TYPICAL PAVEMENT MARKINGS AT ENTRANCE RAMPS

LAST REVISION 11/01/23	REVISION DESCRIPTION:		FY 2024-25 STANDARD PLANS	INTERCHANGE MARKINGS	INDEX 711-003	SHEET 2 of 8
---------------------------	-----------------------	--	------------------------------	----------------------	------------------	-----------------

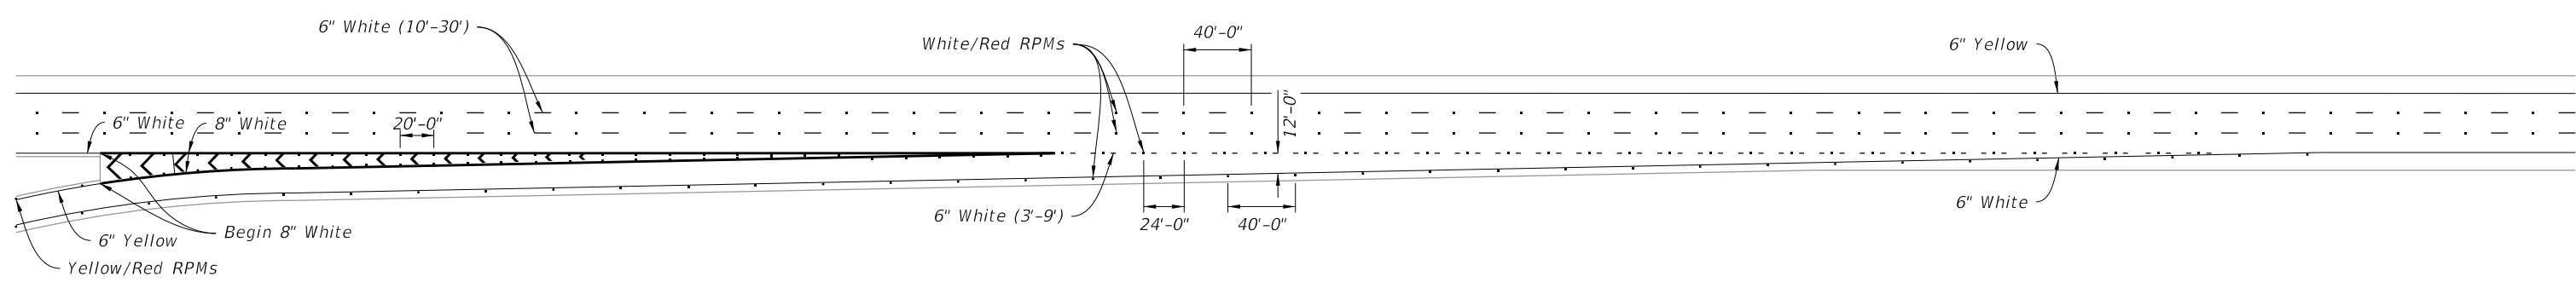
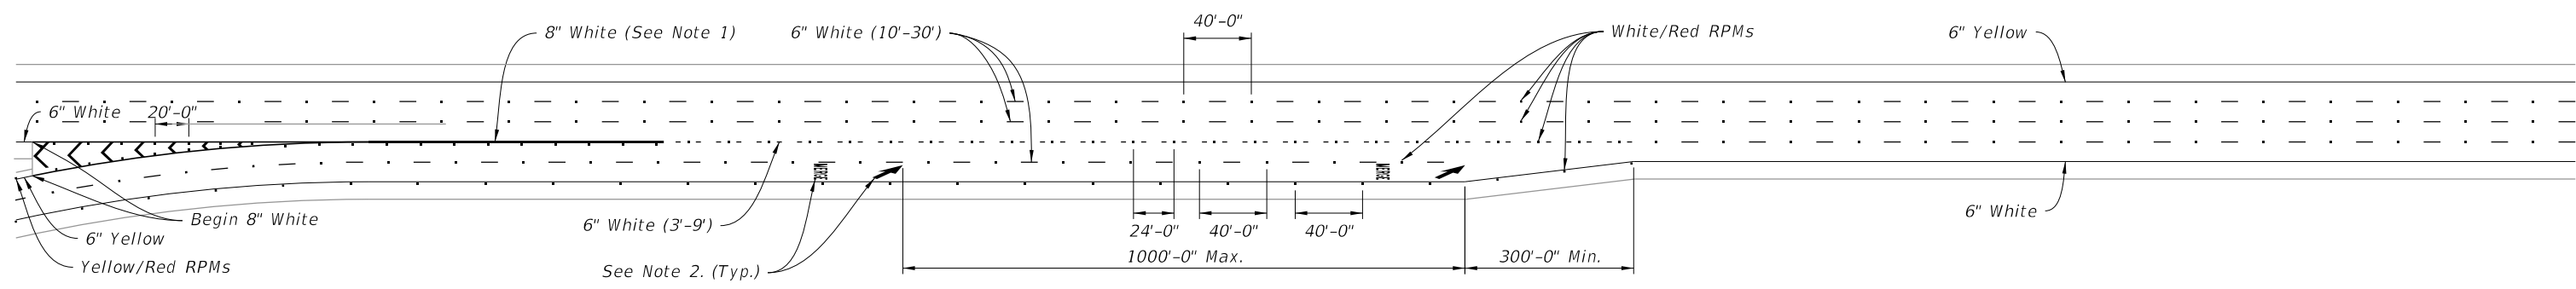
Revised Note to clarify use of dotted interchange line.

1. Extend this 8" white Pavement Marker one-fourth the length of the acceleration lane from the gore markings.
2. See Index 711-001 for pavement message dimensions and details.
3. Discontinue the 6" White (3'-9") Dotted Interchange Line where the merging taper begins for a Single-Lane Parallel-Type Entrance Without Added Lane. Merge Pavement Message and Arrow only used for Two-Lane Entrances.
